**Application for Observations to a Neighbouring Planning Authority**

<b>Reference</b>	PA/24/00657 (GLA reference 2023/0836)
<b>Site</b>	Plot 1 at the former Bishopsgate Goods Yard site, Braithwaite Street, London, E1
<b>Ward</b>	Weavers (LB Tower Hamlets), Hoxton East and Shoreditch (LB Hackney)
<b>Proposal</b>	Observations requested by the Greater London Authority (GLA) in relation to 'Application for all Reserved Matters Approval (Access, Appearance, Landscaping, Layout and Scale) in respect of Plot 1 (GLA reference 2023/0836), pursuant to LB Tower Hamlets outline planning permission reference PA/14/02011 (GLA reference GLA/1200cd/12); LB Hackney planning permission reference 2014/2427 (GLA reference GLA/1200cd/13) dated 25/03/2022, for the erection of a building comprising 51,309 sq m of office floorspace (Class B1), 831 sq m retail uses (Use Class A1-A5), 6,392 sq m plant and ancillary space, landscaping, public realm, and all associated works.'
<b>Summary Recommendation</b>	Raise objections and detailed comments in response to a request for observations from the Greater London Authority

**EXECUTIVE SUMMARY**Plot 1 (RMA Site)

Figure 6: Local Plan Bishopsgate Goods Yard Site Allocation (Site Allocation boundary in red; public square in yellow; strategic pedestrian/ cycling routes in orange; green grid in green)

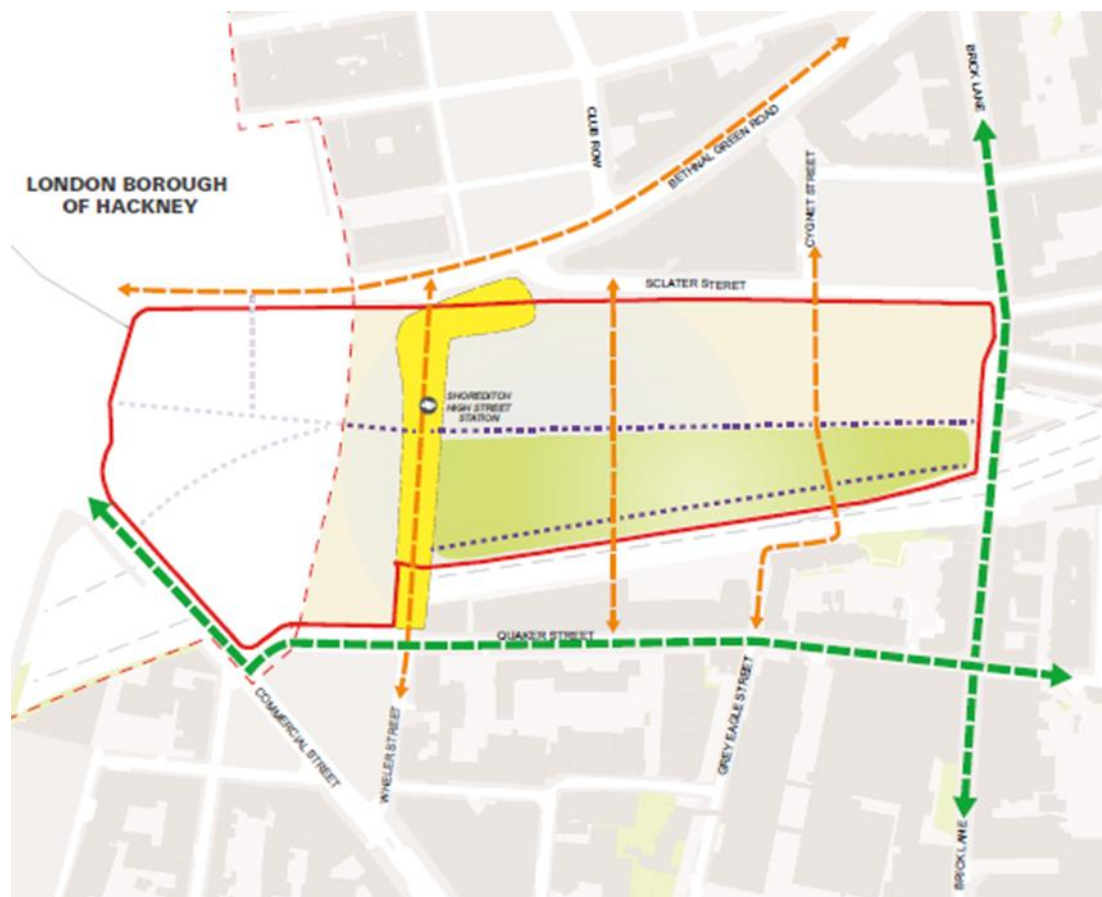
aspirations (shown in figure 6) for a public square and increased public realm at this location. The proposal would be contrary to the Design Guide, as shown in appendix 1.4.

Figure 7: Proposed north elevation (on Bethnal Green Road) with LB Tower Hamlets to left (east) of red line. Blue outline is minimum parameter massing; green outline is maximum parameter massing

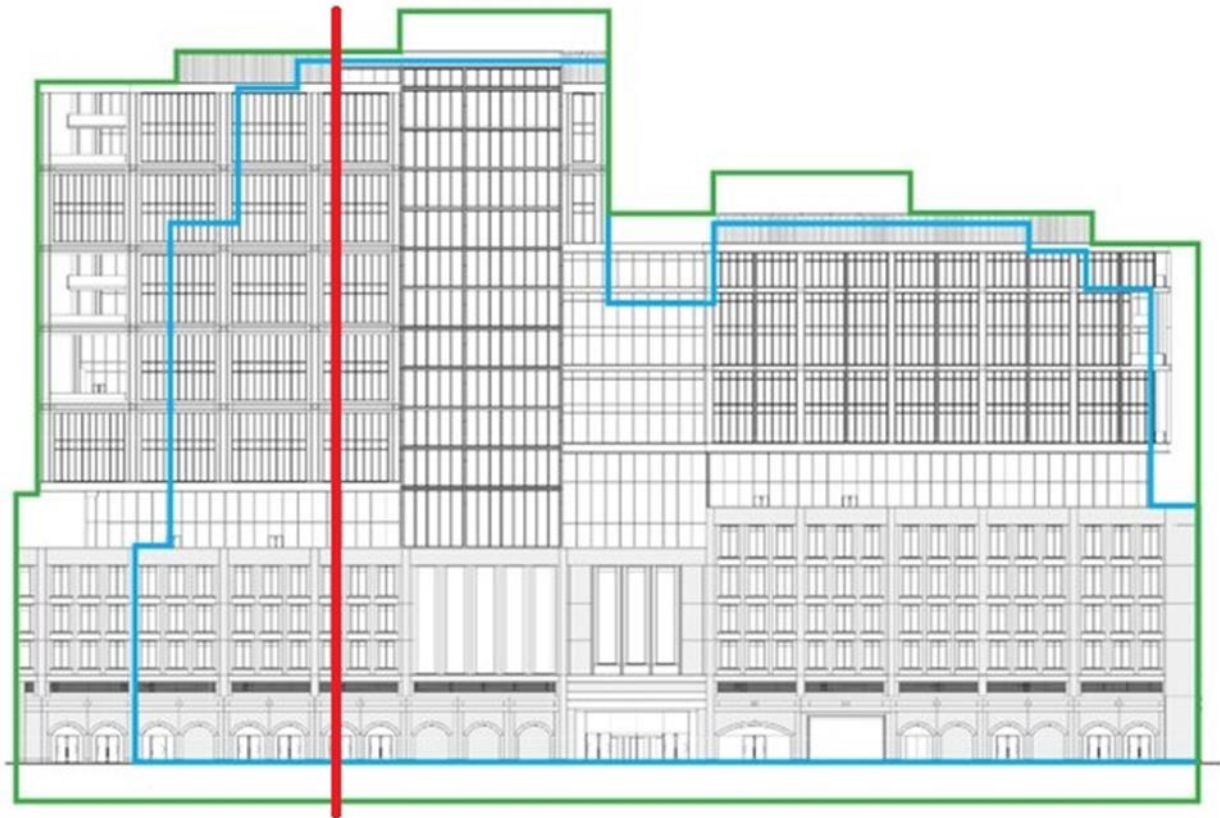
- 7.25 The middle and base of the eastern end of the building (see figure 7 and figure 8) seem unrelated, and a design detail that introduces a familial language would help integrate them and improve the building's cohesion. On the northern (see figure 8) and southern (see appendix 1.3) elevations, the impact of the glazed ribbon detail, a striking transitional feature of the proposals, has been reduced because rather than being recessed (as it is on the western and eastern ends), it is in the same plane as the upper parts of the building.

7.28 Paragraph 4.4.21 of the Design Guide requires that the service access into Plot 1 from Bethnal Green Road will be visually integrated into the proposed architecture – officers are not convinced that it is. In the proposed north elevation (see figure 7), the entrance to the service yard seems out of proportion with adjoining arches, being both higher and wider. It is also extremely utilitarian in appearance. Consideration should be given to introducing an arch to the top of this service yard access. Assuming that gates are required, it should be ensured that these are sufficiently decorative, bespoke and attractive.

- 7.42 As shown in figure 7 and figure 9, the proposal involves extending to the maximum parameter of both building footprint and massing. The proposal would not introduce a cantilevered recess. As shown in figure 9, no additional public realm would be provided although it appears that pedestrians could potentially cut through/ past the corner retail unit (marked as number 2) – this would not constitute an adequate colonnade space. It is understood that this space would be shuttered at night to prevent anti-social behaviour – the principle of closing such a space at night is supported, however the space itself is wholly unacceptable. Any cantilevered or colonnade space would require full details of management strategy, process of activation (through elements such as lighting, public art and incorporating retail frontages) and the use of decorative and bespoke detailing to be secured by condition.

Figure 9: Proposed 'Station Square.' 1 is the overhanging gantry; 2 is retail frontage within an enclosed area; 4 is retail frontage to Plot 4; 5 is bollards;

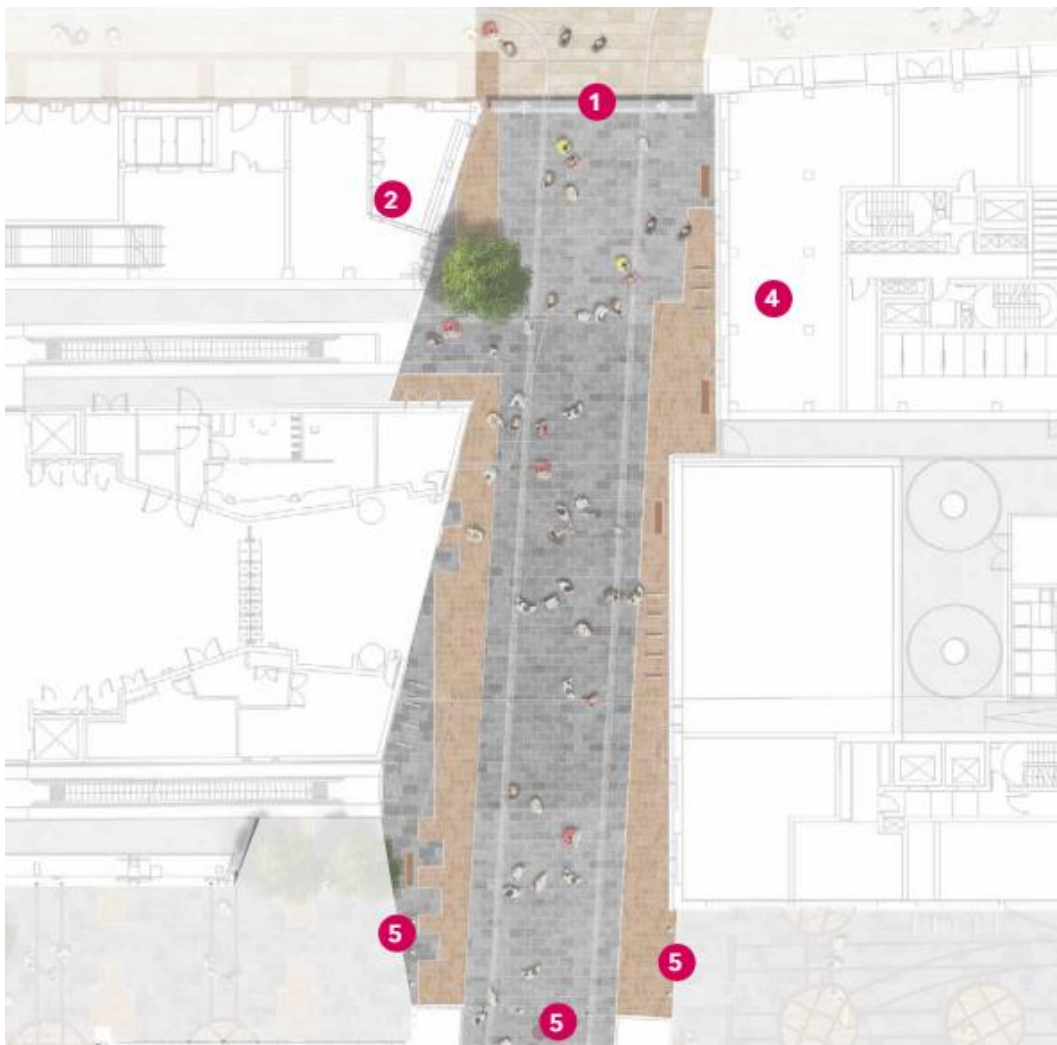
- 7.40 Figure 9 shows the proposed 'Station Square,' within LB Tower Hamlets on Braithwaite Street. Three sets of bollards are proposed around the eastern end of the building on Braithwaite Street – on both sides of Middle Road (the west-east route) and to the south just before the Overground viaduct. It is assumed that these are hostile vehicle mitigation measures – pedestrian desire lines should be considered in the final HVM strategy. Officers would need to see the final HVM strategy at this stage in order to be able to fully assess public realm proposals and ensure minimal clutter along with necessary security measures. If the HVM strategy cannot be provided at this stage then it should be secured by condition.

- 7.43 The proposed 'Station Square,' with no additional public realm would not practically constitute a 'square' and figure 8 and figure 10 show that it would appear 'hemmed-in' by Plot 1 and Plot 4 tall building development on each side. The proposal also goes against the Site Allocation

- 7.45 Further to above, bollards on Braithwaite Street (shown as number 5 on figure 9) should be minimalised and rationalised. Folding or lowerable bollards should be moved to the northern threshold, underneath where the gantry is shown (number 1), which would create an improved, relaxed pedestrian zone on the approach to Shoreditch High Street station, whilst still allowing emergency vehicle access.

Figure 11: Image showing surrounding land uses (residential in pink)

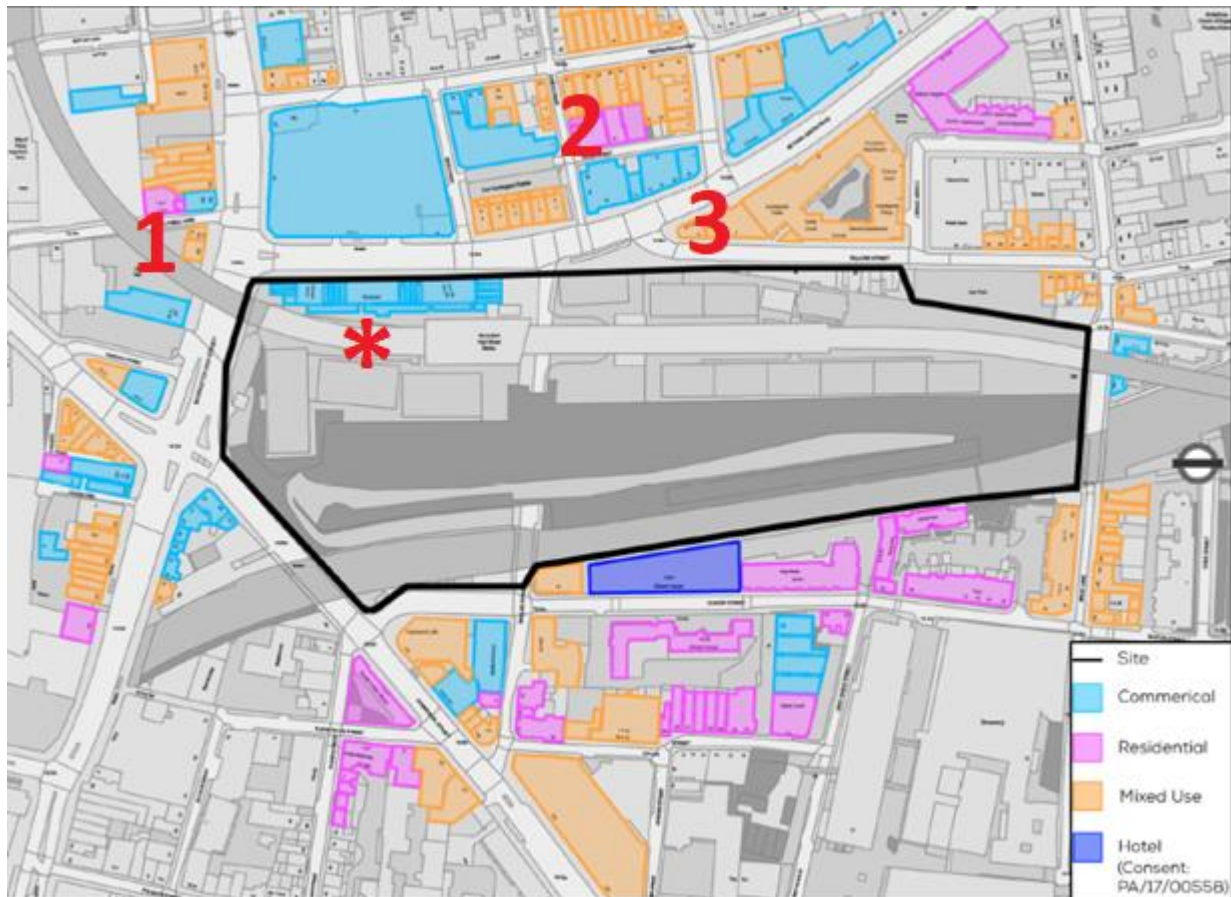
- 7.59 As mentioned above, the nearest residential units to Plot 1 appear to be those shown on figure 11. Major adverse impacts to daylight and sunlight were attributed to these existing homes. For 28-30 Bethnal Green Road, it would appear that impacts would mainly arise from the interaction with Plot 4 and Plot 5 rather than Plot 1 which is further away. For 2-4 Chance Street, it was factored in that this second floor property had low existing levels and was self-restricted by its

Appendix 1.2: Existing view of approach to Shoreditch High Street station from Bethnal Green Road

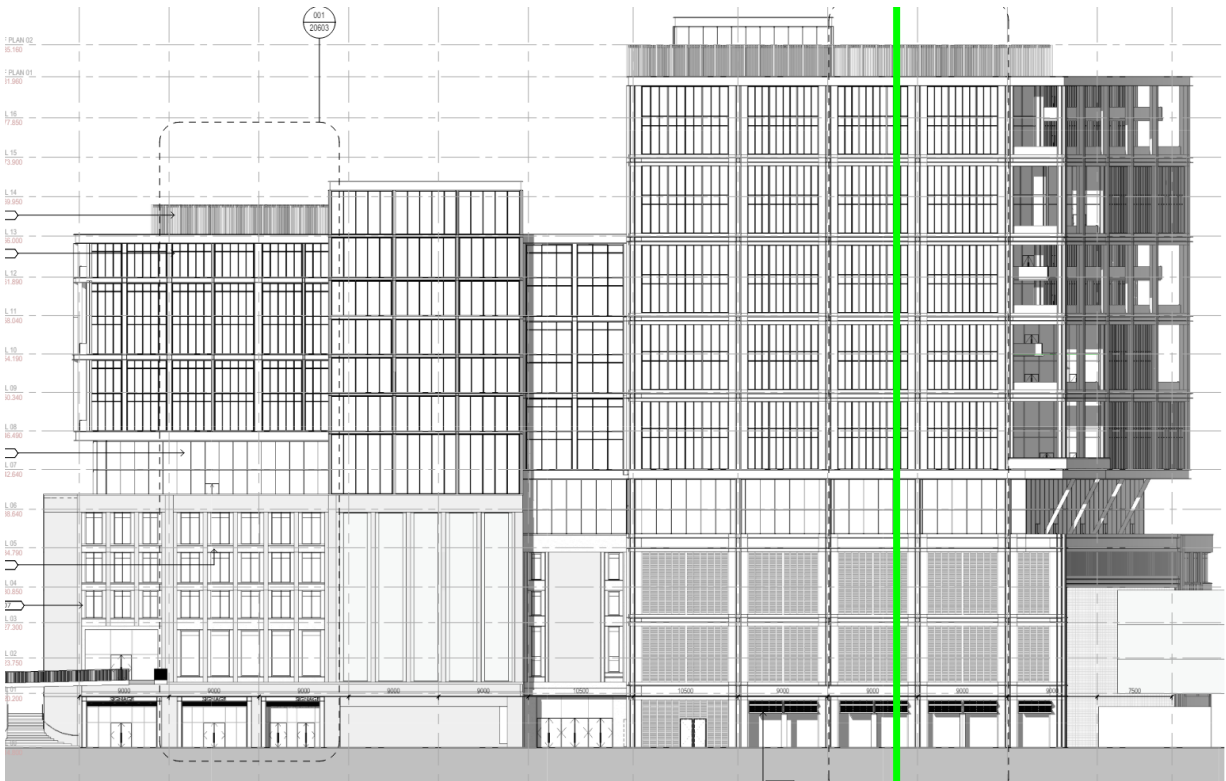
- 7.44 Appendix 1.2 shows the existing situation around Shoreditch High Street, whereby BOXPARK is setback to allow some public realm, open space and relief towards the station approach. This layout also allows the Shoreditch High Street station totem and signage on the viaduct to be clearly visible to passers-by on Bethnal Green Road. Building out to the maximum parameter massing at the eastern end has obscured the presence of the Overground station and fails to provide any meaningful public realm to improve the situation.

Appendix 1.4: Guidance for 'Station Square' in Design Guide

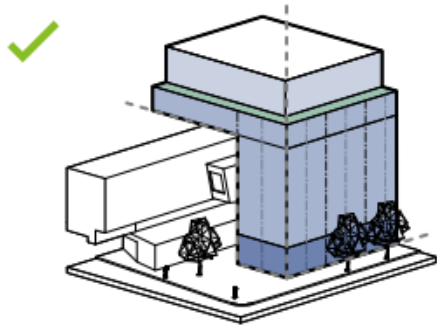
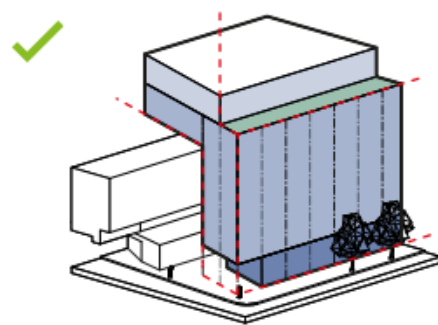
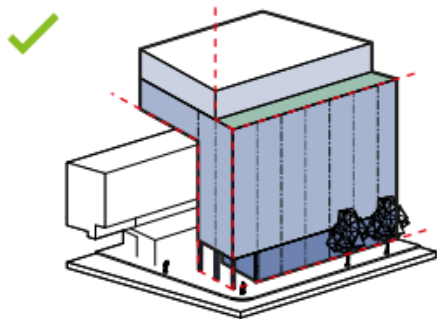
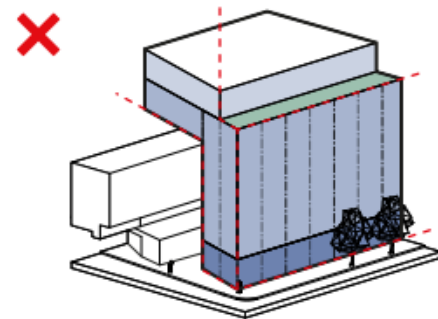
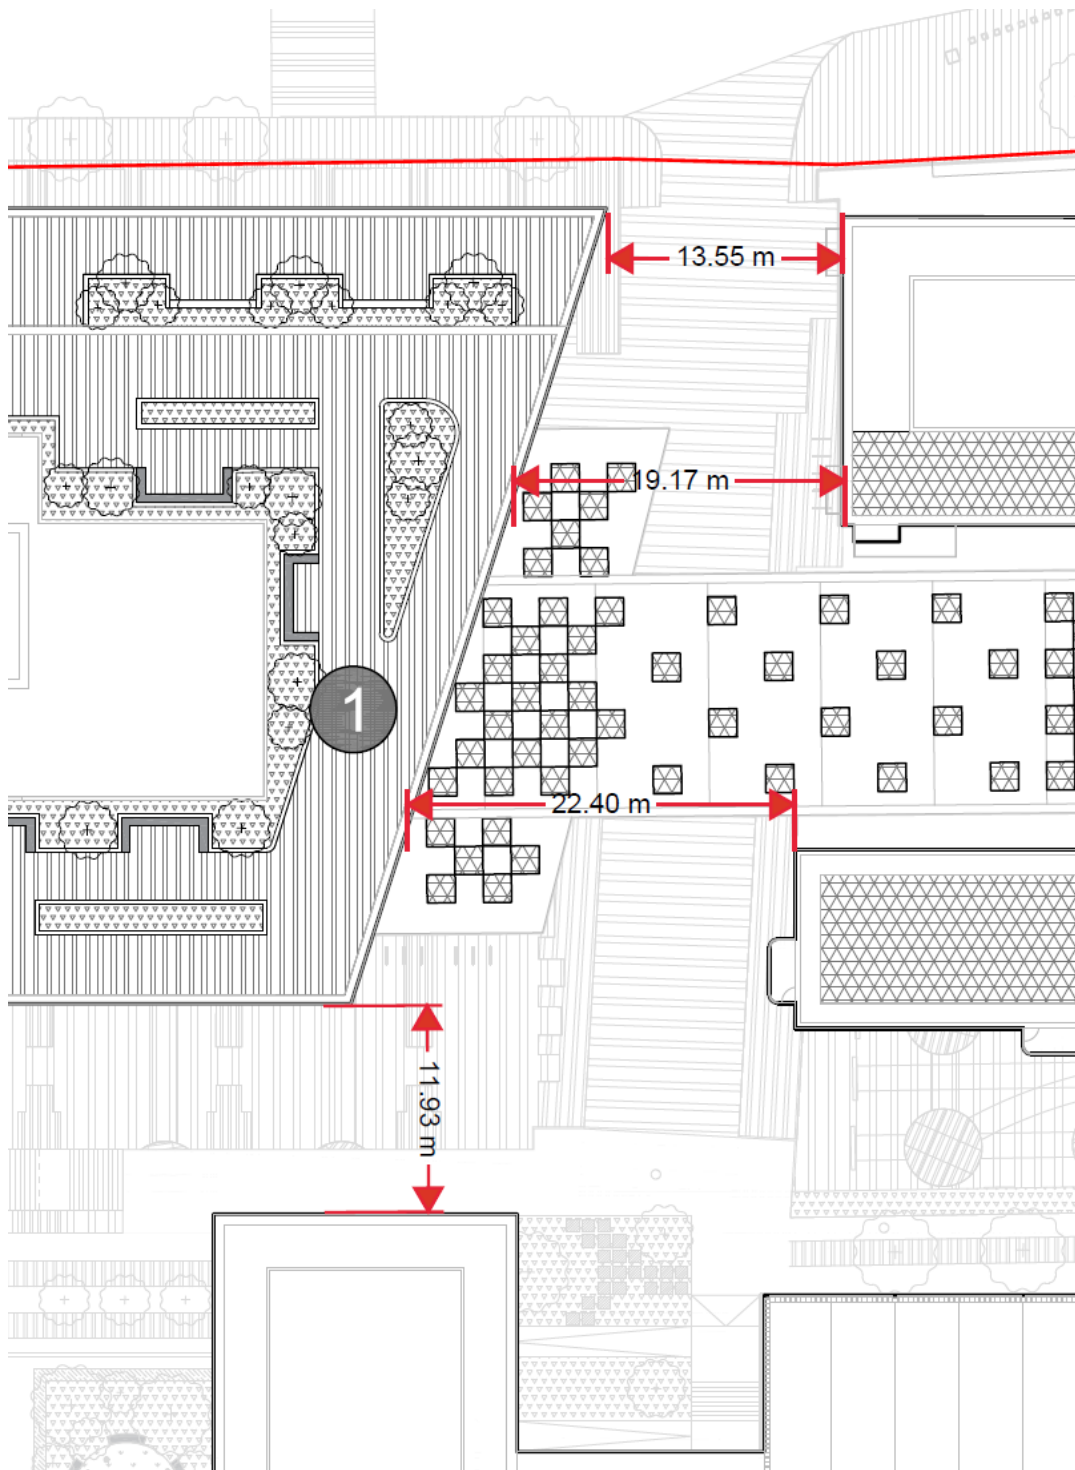
- 7.41 Appendix 1.4 illustrates the Design Guide section relating to 'Station Square' which states that *'increased public space will be provided at the north-east corner of the plot (between Bethnal Green Road and Shoreditch High Street. This will ensure adequate and appropriate public realm is delivered in this potentially busy location.'* The Design Guide further describes that this *'will be achieved'* by either building to the minimum parameter extents (shown in blue outline on appendix 1.8), introducing a cantilevered recess or introducing a colonnade when building to the maximum parameter.

Appendix 1.6: Proposed east elevation (within LB Tower Hamlets) showing minimum parameter massing in blue outline and maximum parameter massing in green outline

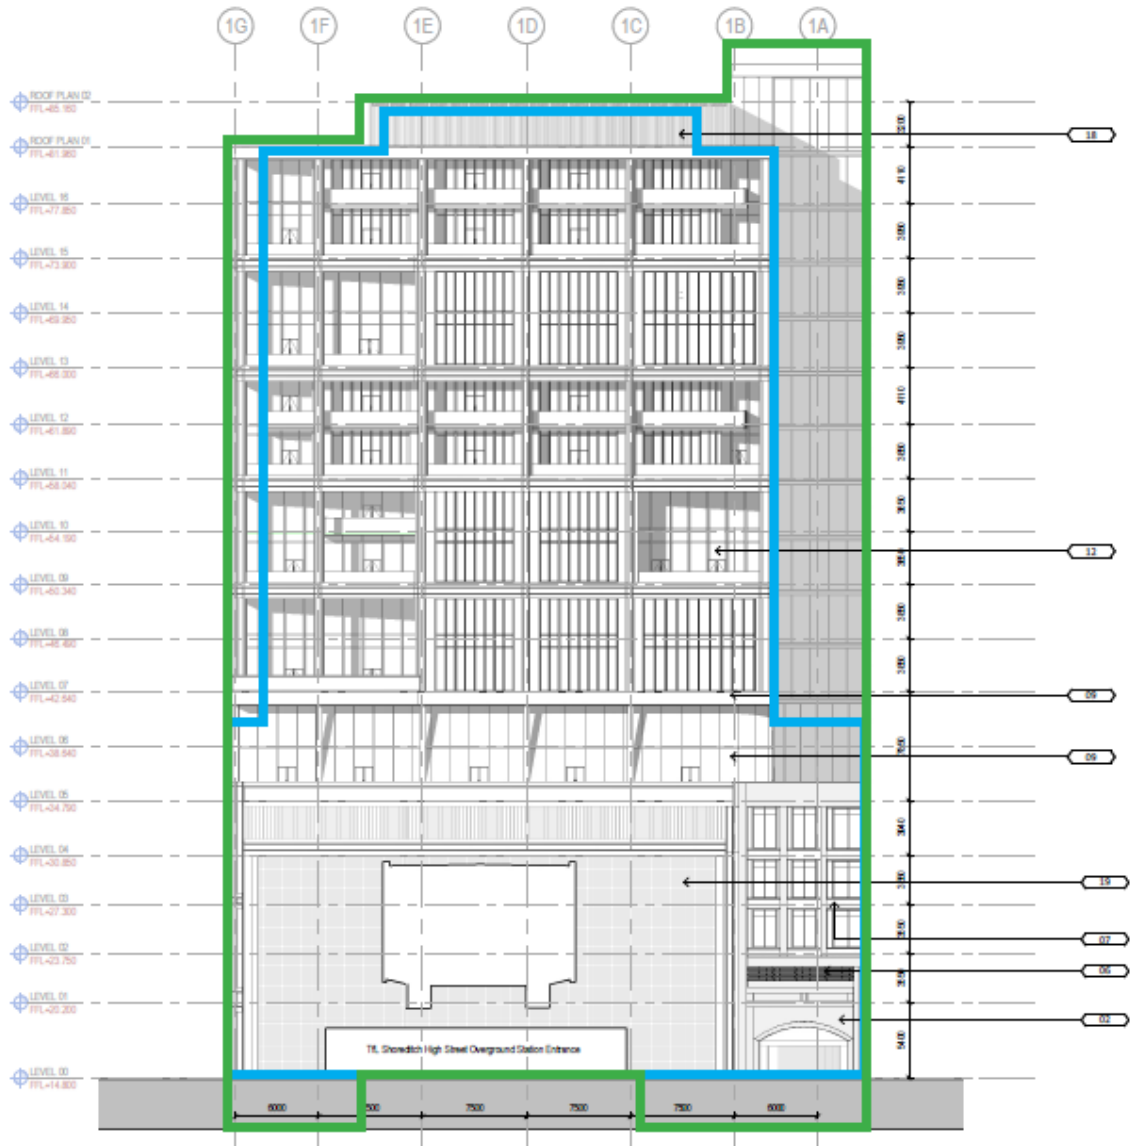
7.31 This part of the proposed building is within LB Tower Hamlets (shown in figure 8 and appendix 1.6). Officers would have liked an opportunity to review and discuss the design and layout of this section of the building in greater detail at pre-application stage. The structural piers whilst reflected between the upper and lower sections of the building, are top heavy, with the width of the structure at the top of the building extending beyond the dimensions of the lower brick piers. Ideally the structure to the top half of the building would be lighter in appearance.
